SUBJECT: Forwards response to requests 5 through 12 of addl info re
 NUREG-0737 Item II. D. 1, "Performance Testing of Relief &
 Safety Valves."

Subject: Oconee Nuclear Station
Docket Nos. 50-269, -270, -287
"Performance Testing of Relief and Safety Valves"
Request for Additional Information

"PERFORMANCE TESTING OF RELIEF AND SAFETY VALVES"
RESPONSE TO REQUEST FOR ADDITIONAL INFORMATION
(5 THROUGH 12)

Figure 1. RELAP5 Model of Pipe with Bend

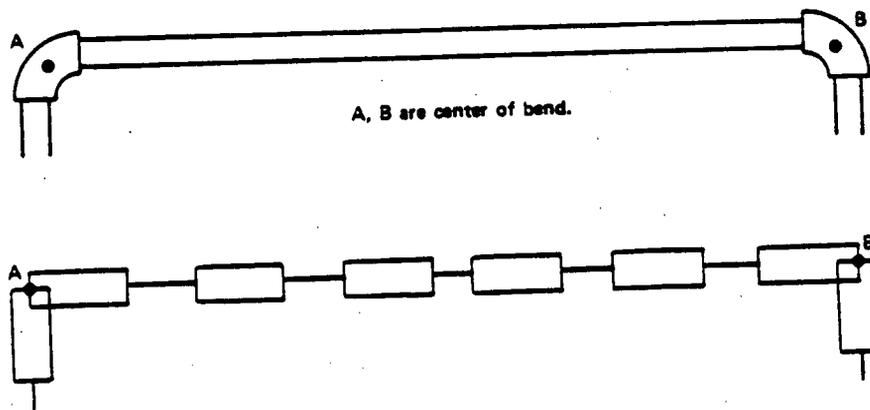
Discuss how REPIPE calculates piping forces from RELAP5 output and provide results of verification calculations for EPRI/CE tests for our review.

In order to conform to the modeling guidance given by the REPIPE code authors, each straight leg of piping was modeled with one or more straight control volumes that extended to the center of the bends at each end. This concept is illustrated in Figure 1. The turning of the fluid is assumed to occur in this mid-bend junction, not within a control volume. The pipe stress model does not have to include a node at the bend midpoint to match this resulting junction. In fact, the associated piping nodes were at either end of the bend where the forces can be input in line with the pipe.

Placing a turn in a junction as shown in Figure 1 presents no physical problem. In fact, the turning loss coefficients are input to RELAP5 at junctions. But equation (5) is applicable to a fluid volume, not a point or area (junction). This purely mathematical restriction is circumvented by assuming a massless "virtual volume" in the junction.
